# **Development Assessment Panel of City of Prospect**

- 5.1 2A Richman Avenue, Prospect - Four Storey Residential Flat Building comprising 10 Dwellings with Associated Car and Bicycle Parking and Landscaping (DA 050/82/2015)

- 5.2 227-229 Prospect Road Prospect – Four Storey Residential Flat Building comprising 24 Dwellings with Associated Car and Bicycle Parking and Landscaping (DA 050/345/2014)

- 5.3 100 Churchill Road, Prospect - Variation to Development Application 050/467/2013 – Four Storey Residential Flat Building Comprising 24 dwellings (DA 050/116/2015)

DATE: 29/05/2015  
DRAWING NUMBER: LS.011.15

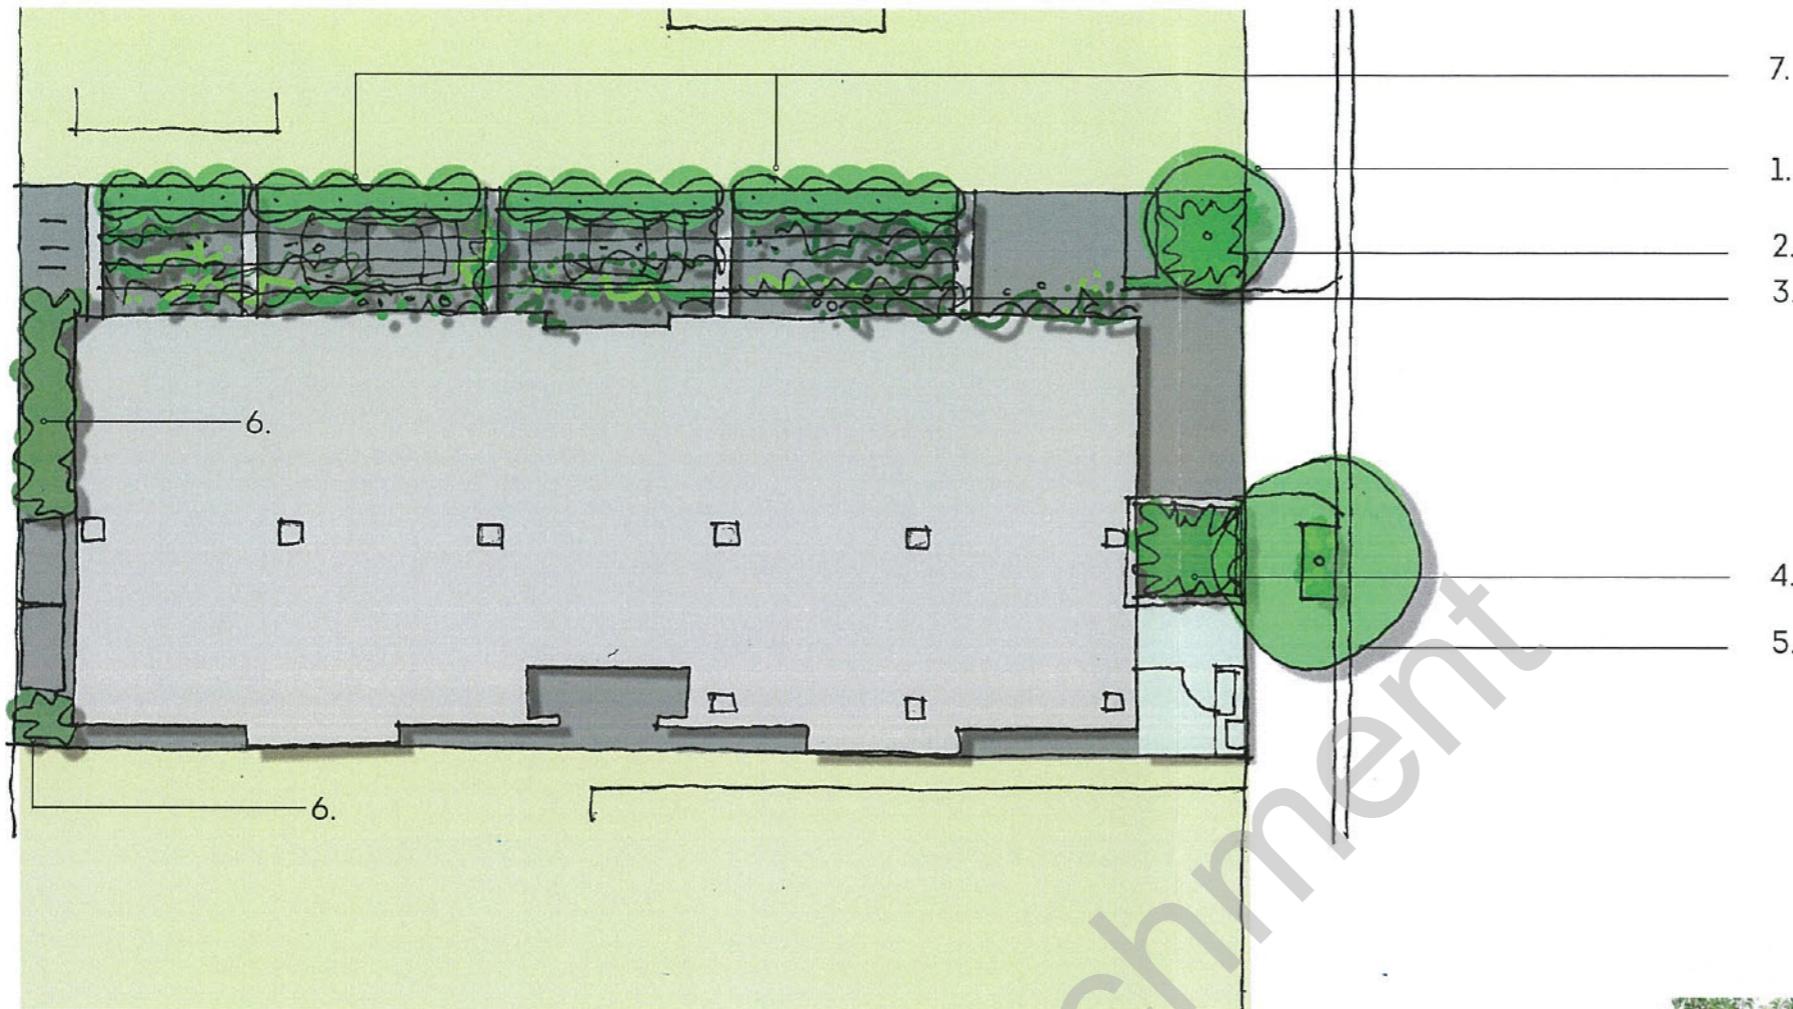
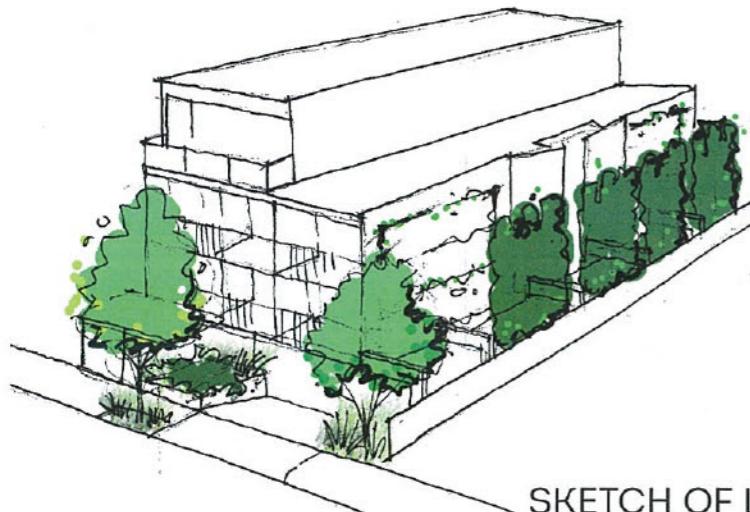
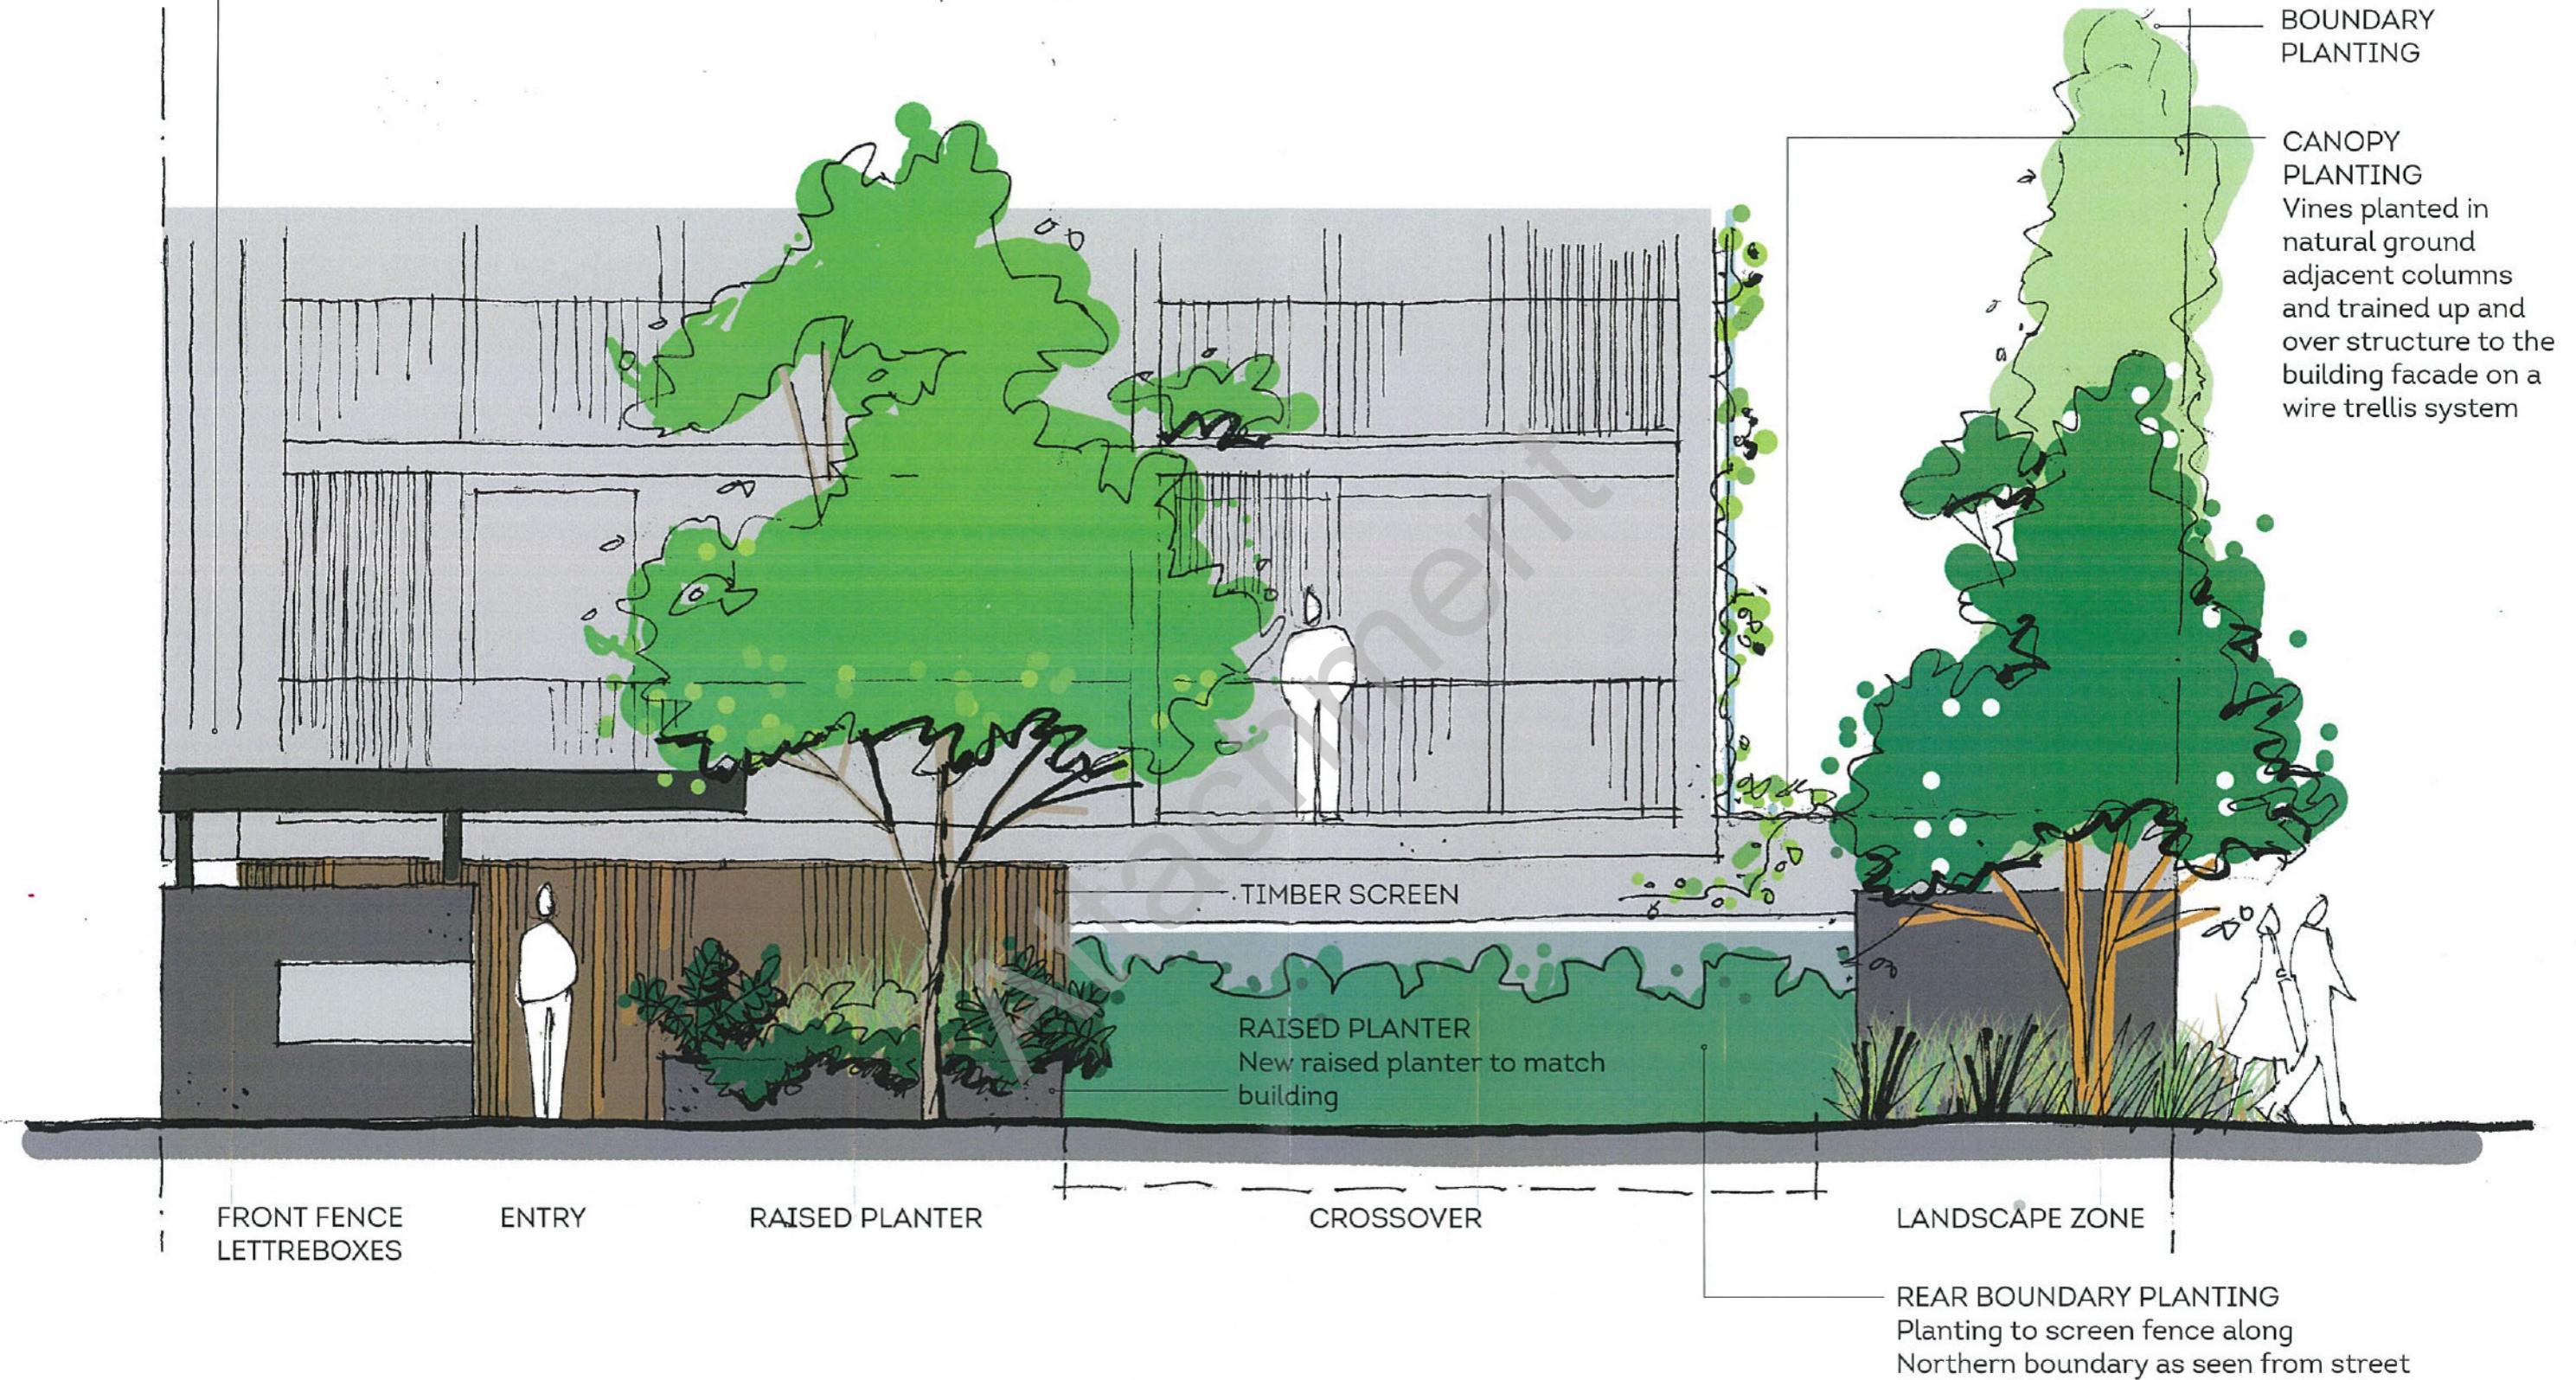
- 6.2.1 The DAP previously resolved to defer the application so that the applicant could provide additional landscaping detail, including consideration of the width of the landscaping strip adjacent the eastern boundary.

- 6.2.2 Amended landscaping plans have been provided by the applicant (refer **Attachments 11-15**). The variations include a considerably greater extent of tree planting within the subject site, principally through the addition of either Ornamental Pear or Pinnacle Lilly Pilly plantings to the eastern boundary of the site. Landscaping areas forward of the building have been increased in size with additional detail provided on the anticipated height and canopy width of the species selected.

- 6.2.3 The amended landscaping plan would also extend a wire trellis system to the full height of the eastern elevation of the building. This is proposed to allow vines growing over the existing landscape canopy to continue growing up this wall of the building. It is noted that the successful growth of the eastern boundary plantings would also assist in softening the appearance of the building as viewed from the adjacent property. It is recommended that a condition be imposed regarding the continuous maintenance of all landscaped areas.

- 6.2.4 The applicant has proposed an example replacement street tree in the amended landscaping plan. It is noted that the removal and replacement of the street tree would be considered by Council's Infrastructure and Assets Officer through the standard Council process. At that time an assessment of the tree will be undertaken by Council's principal Street Tree Consultant to advise upon the cost of removal and of the contribution to be provided by the applicant for the lost amenity of the tree that will be used in its replacement. As this contribution amount may allow for the planting of multiple replacement trees, the pre-emptive acceptance of the applicant's suggestion may lead to a poorer outcome.

- The vines planted in the ground along the eastern boundary are retained and will continue to attach to the columns but are to now advance up and over this column structure and attach to the building façade onto a wire trellis system. The eastern elevation of the building will, over time, have a softened and 'green' appearance as it will be largely covered in creepers.
- In addition, LCS Landscapes has also advised there is sufficient space along the eastern landscape strip to support tree plantings along the boundary. Depending on planting conditions and final site selections, it is proposed to plan a row of either '*Pyrus calleryana Capital*' or '*Syzygium austral*'

*Pinnacle'*. Both species are well known for their excellent growth within restricted, narrow spaces around car parks and along fences. They both provide exceptional screening properties. In addition to the creepers, the proposed plantings, with heights that will range between 8 – 10 metres (approximately) when fully grown, will be ideal in further softening the appearance of the development when viewed from the east in particular, but also generally from the Richman Avenue streetscape and St Helens Reserve.

- > The street tree to be replaced will be planting to the west of the proposed driveway entrance. The applicant's landscape architect recommends an advanced street tree in the form of a '*Koelreuteria paniculata*' planted within a constructed tree pit with a root director and deep watering provisions to enhance growth and stabilize long term health. Ultimately details of this street tree will be at the discretion of Council's arborists and we welcome any input Council's wishes to provide on this matter.
